# Access Compliance Report

## Public Rights-of-Way

Intersection ID: 16513	Main Street: BILTMORE_DR	Cross Street: COLVILLE_RD	Location: SE
ADA ID: 09CE12ACF0EE	Ramp Type: Perp	Initial Pass/Fail: Fail	Overall Compliance: No
Severity Score: 13.75			
Codes/Mitigation Info/Possible Solution		Field Measurements/Component Compliance

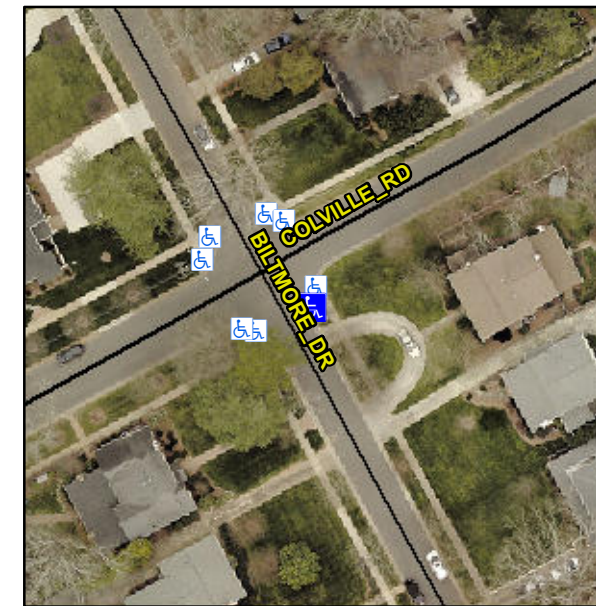
**Remove & Replace Entire Ramp.**

**R304.2.2, R304.5.3**

Compliance	Description	Data	Compliance	Description	Data
N/A	Ramp Length (in)	86.0	No	Ramp Slope (%)	10.4
Yes	Ramp Width (in)	54.0	No	Ramp XSlope (%)	4.0
N/A	Flare Type LT	N/A	N/A	Flare Type RT	N/A
N/A	Flare Slope LT (%)	N/A	N/A	Flare Slope RT (%)	N/A
N/A	Flare Traversable LT?	N/A	N/A	Flare Traversable RT?	N/A
N/A	Landing Length (in)	N/A	N/A	DWS Provided?	N/A
N/A	Landing Width (in)	N/A	N/A	DWS Contrast?	N/A
N/A	Landing Slope (%)	N/A	N/A	DWS Length (in)	N/A
N/A	Landing X Slope (%)	N/A	N/A	DWS Full Width?	N/A
N/A	Landing Curb? (Y/N)	N/A	N/A	DWS Offset (in)	N/A
N/A	Shared Landing?	N/A			
N/A	Gutter Ponding?	N/A	N/A	Gutter Slope (%)	N/A
N/A	Gutter Lip Ht (in)	N/A	N/A	Gutter X Slope (%)	N/A
N/A	Painted X Walk1?	No	N/A	Painted X Walk2?	N/A
	X Walk 1 Direction	To SW		X Walk 2 Direction	N/A
N/A	X Walk 1 Width (in)	N/A	N/A	X Walk 2 Width (in)	N/A
	X Walk 1 Slope (%)	2.1		X Walk 2 Slope (%)	N/A
	X Walk 1 X Slope (%)	1.4		X Walk 2 X Slope (%)	N/A
